OCP CLB Impedance Analysis

Ricky Lai
Hewlett Packard Enterprise

Why there is BIG
impedance drop on
OCP CLB?

SMP Header

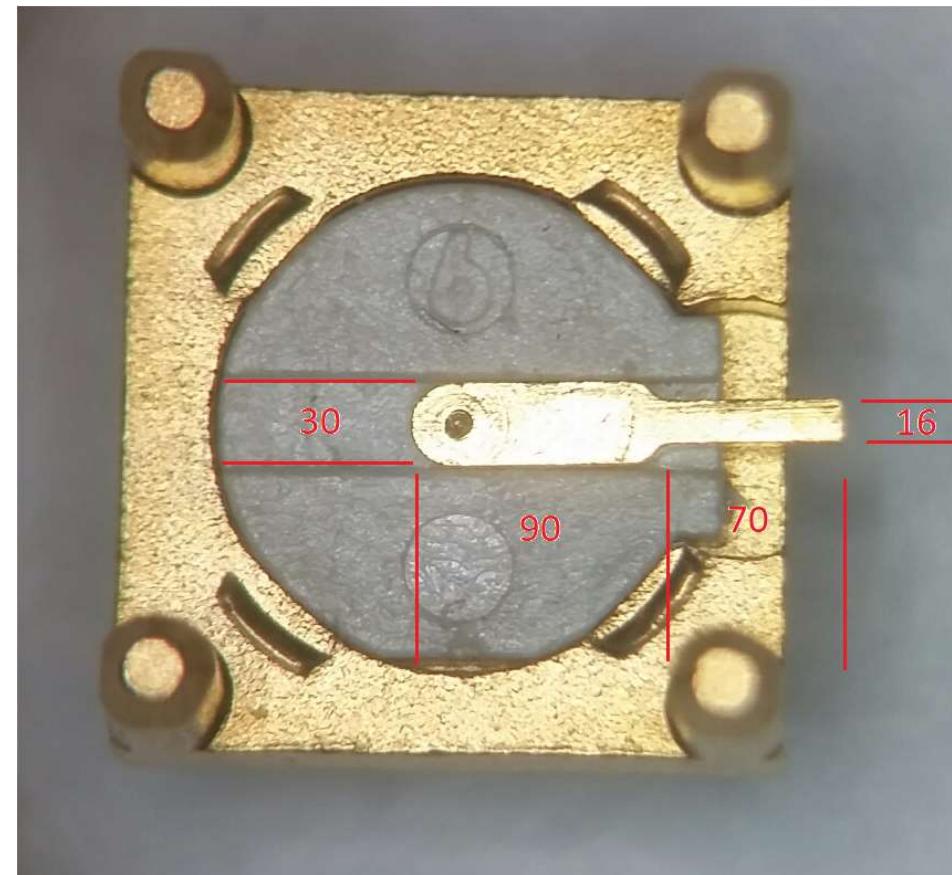
- 30 mil wide metal on the SMP header creates large capacitance from L2 and thus causes significant impedance drop

- Create void underneath the SMP header on L2, L3 & L4

How does PCI-SIG CLB get around?

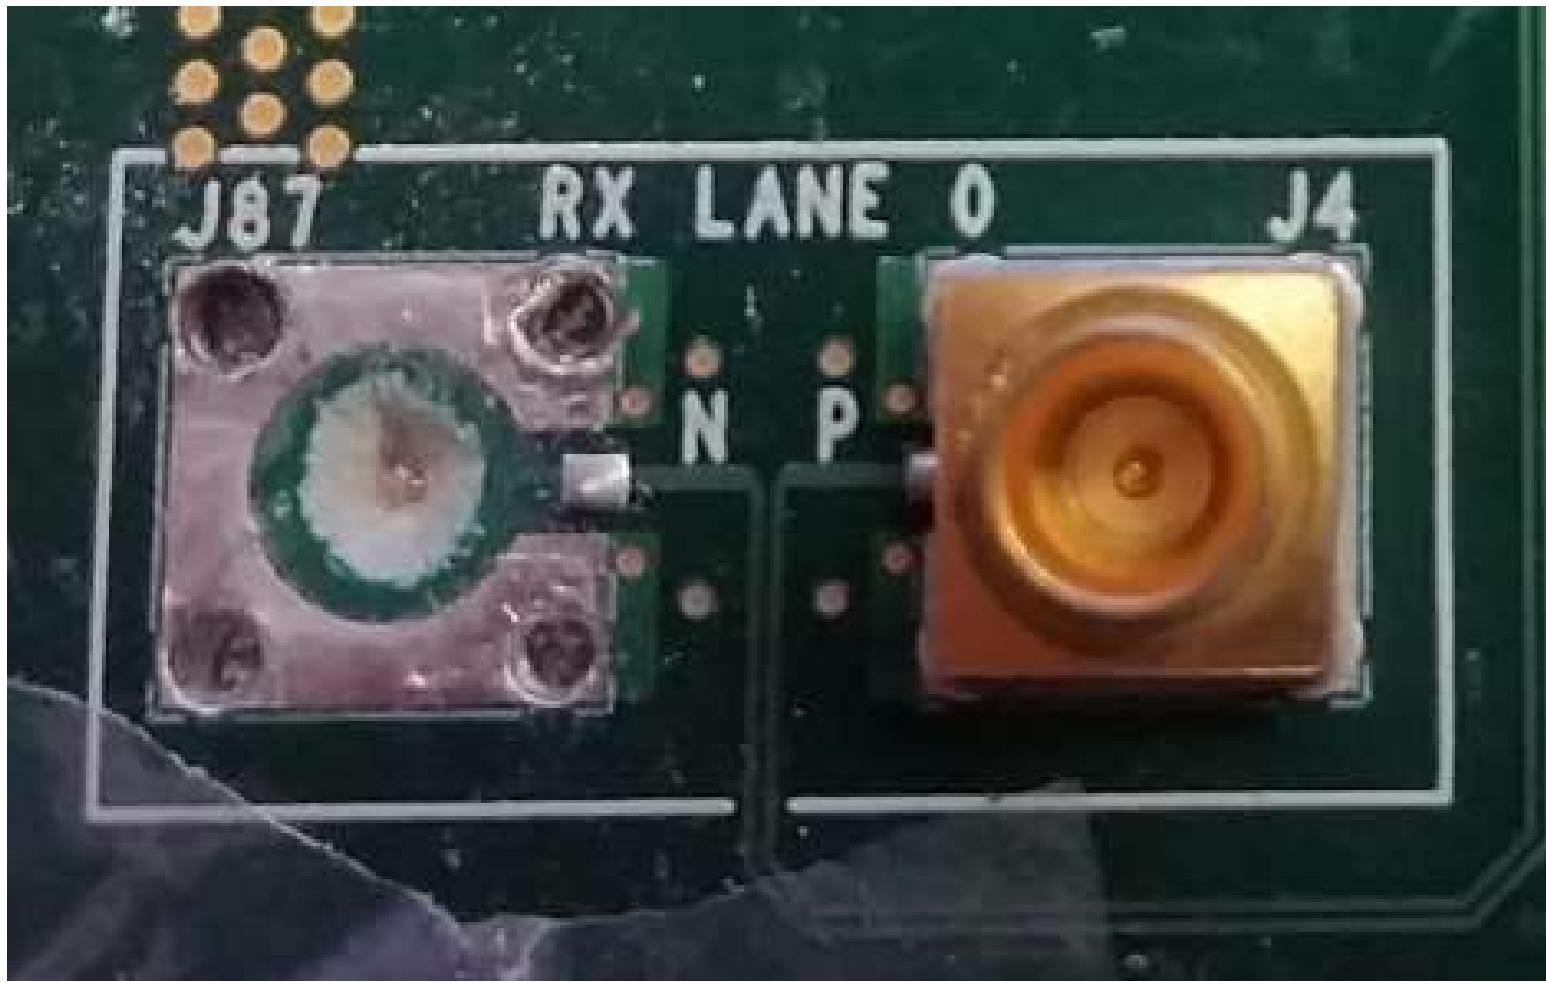
- Create void underneath the header on L2

OCP CLB – L2 & L3

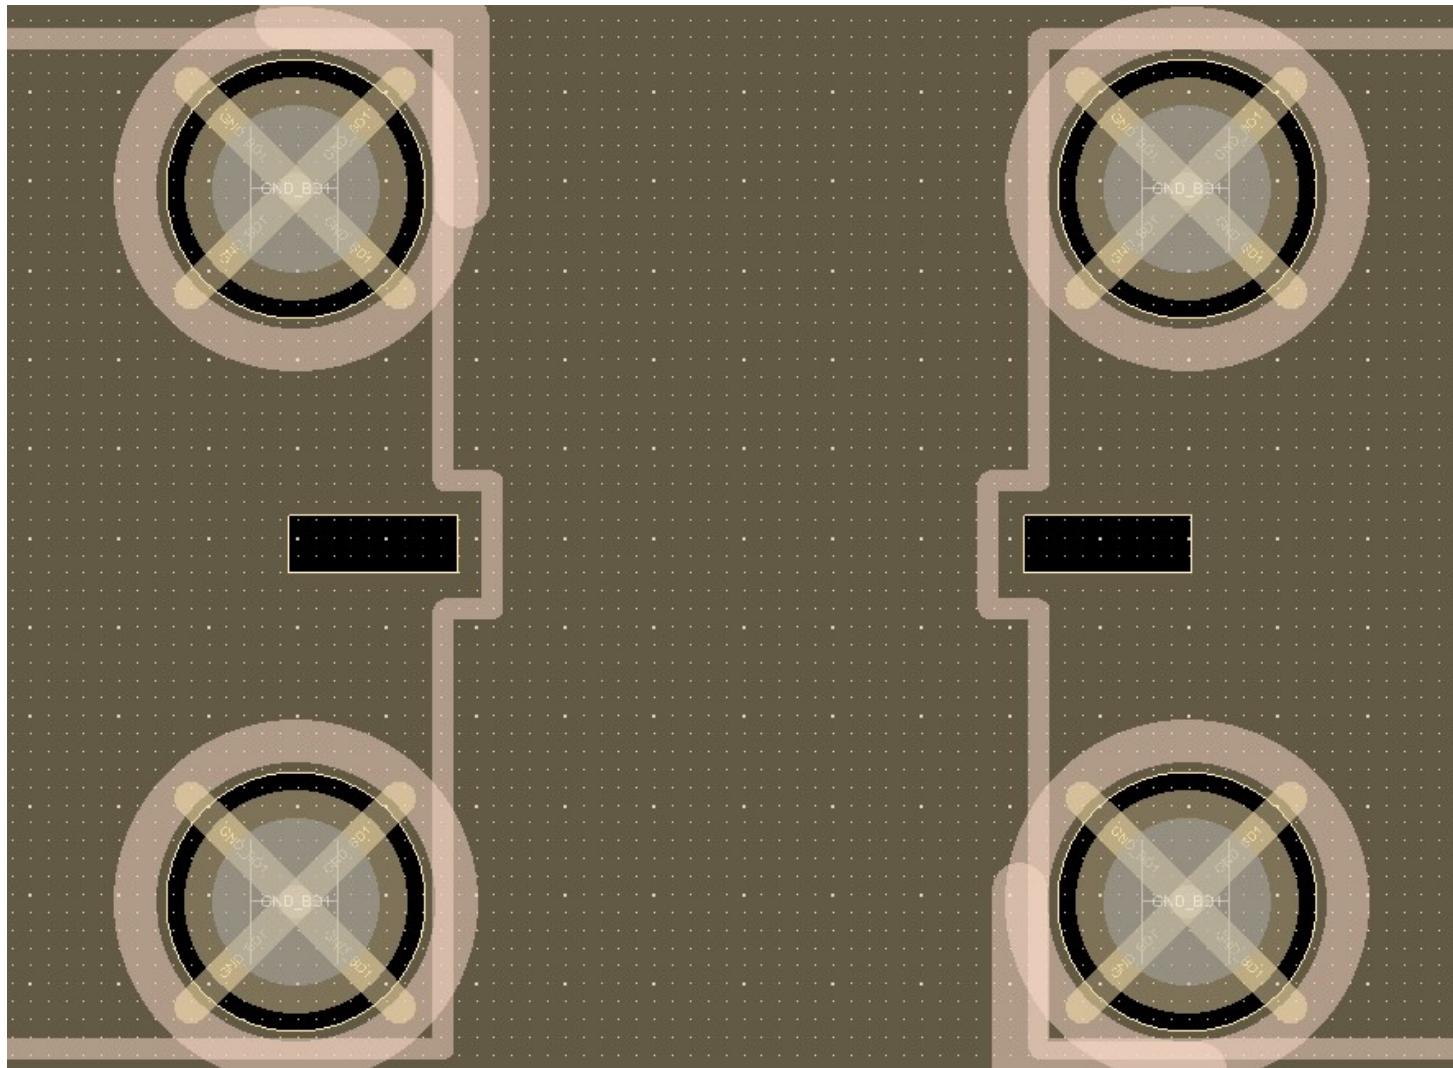
13 impedance if L2 is reference

37 impedance if L3 is reference
(void on L2)

40 impedance if L4 is reference
(void on L2 & L3)

43 impedance if L5 is reference
(void on L2, L3 & L4)
